MILITARY SPECIFICATION

SYNCHROS, 60 CYCLE, 115 VOLT

This amendment forms a part of MIL-S-2335, dated 8 August 1950, and is mandatory for use by all Departments and Agencies of the Department of Defense.

FIGURE 9. NOISE TEST FIXTURE

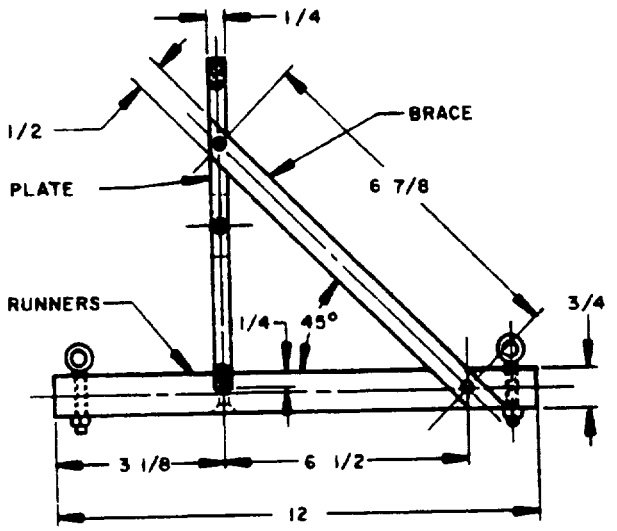
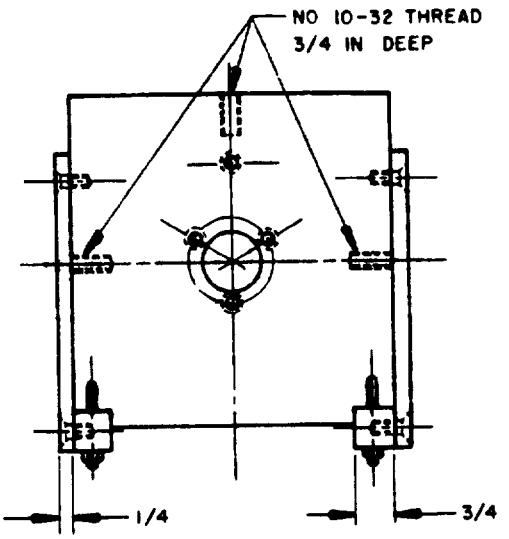
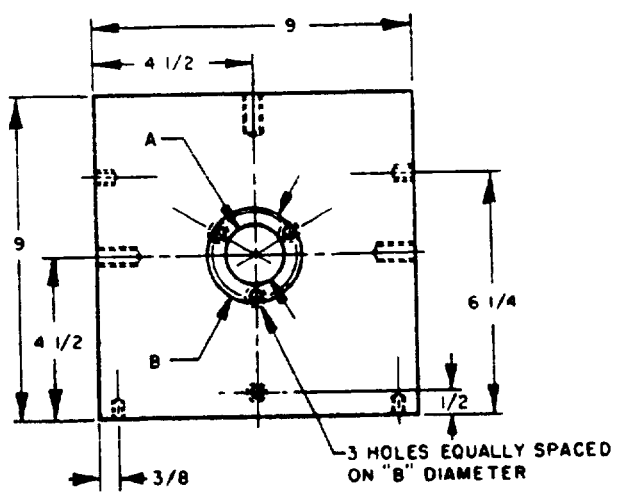
Replace page 58 (Figure 9 "Block Diagram of Synchro Noise Test") with new page 58. (Figure 9 "Noise Test Fixture") See page 3 of this amendment.

for conducting the structureborne noise test. The alternate mounting instructions described herein shall be used only when specified by the procuring activity The synchro shall be mounted on the noise test fixture described by Figures 9 and 10 utilizing standard mounting hardware. The synchro shall be oriented on the test fixture with the synchro zero mark in the vertically up position. The unit and fixture combination shall be suspended as shown in Figure 10 in such a manner that the axis and the top edge of the mounting plate are horizontal within five degrees"

FIGURE 10. TEST FIXTURE APPLICATION FOR STRUCTUREBORNE NOISE TESTING

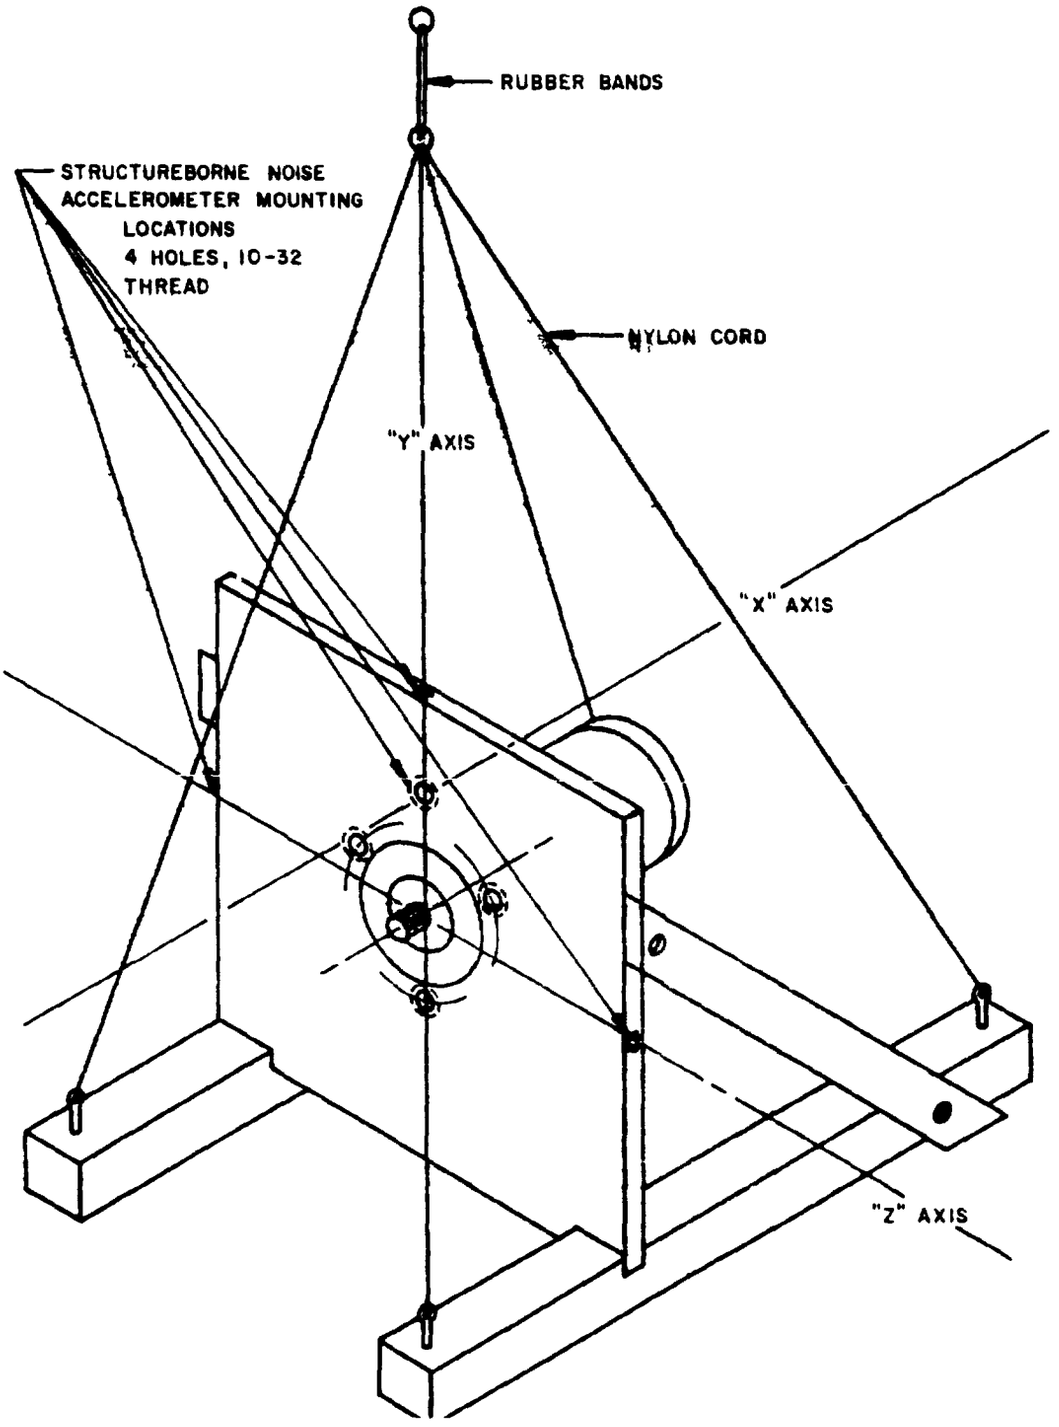
Following page 58 (Figure 9) add new page (Figure 10 "Test Fixture Application for Structureborne Noise Testing") See page 4 of this amendment.
